# UNITED STATES PATENT AND TRADEMARK OFFICE

APPLICATION NO.	FILING DATE	FIRST NAMED INVENTOR	ATTORNEY DOCKET NO.	CONFIRMATION NO.
10/572,378	03/16/2006	Kazuyoshi Koizumi	NIF-107	5660
32628 7590 04/28/2009 KANESAKA BERNER AND PARTNERS LLP 1700 DIAGONAL RD SUITE 310 ALEXANDRIA, VA 22314-2848				
EXAMINER RASHID, MAHBUBUR				
ART UNIT 3657		PAPER NUMBER		
MAIL DATE 04/28/2009		DELIVERY MODE PAPER

### Office Action Summary

### **DETAILED ACTION**

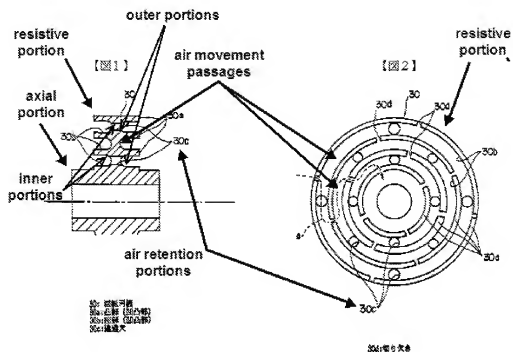
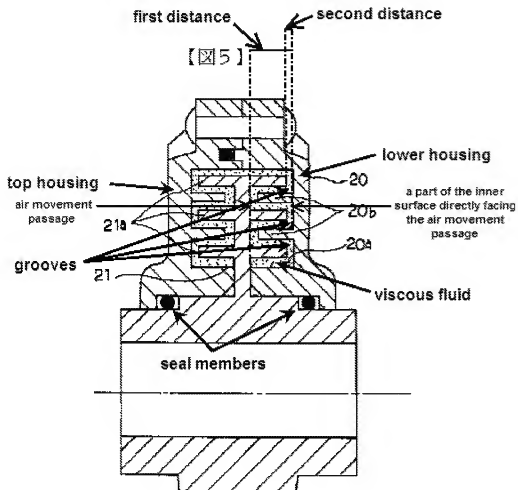
said housing (20) has an inner surface facing the resistive portion (30a), a first distance (see fig. above) between the air movement passage (see figs. 1 and 2, the depressed grooves between the portions 30c) of the resistive portion (30a) and a part of the inner surface directly facing thereto, and a second distance (see fig. above) between a portion of the resistive portion radially away from the air movement passage (see figs. 1 and 2, the depressed grooves between the portions 30c) and a part of the inner surface directly facing thereto, said second distance being less than the first distance.

**Re-claim 3**, see the air retention portions (30c) and the air movement passage see figs. 1 and 2, the depressed grooves between the portions 30c and see also the figure above).

**Re-claim 5**, see the radially inner and outer portions (fig. 1; see also the figure above).

a viscous fluid housed inside the housing (see fig. 5 and see also fig. above);

wherein said resistive portion (30a) includes multiple air retention portions (30C) provided in a circumferential direction, and said housing (20) includes a circumferential groove (see fig. 5 and the fig. above) facing the air retention portions (30c) and operating as an air movement passage (see figs. 1 and 2, the depressed grooves between the portions 30c) connecting two of the air retention portions (30c).

**Re-claim 12**, see the radially inner and outer portions (fig. 1; see also the figure above).
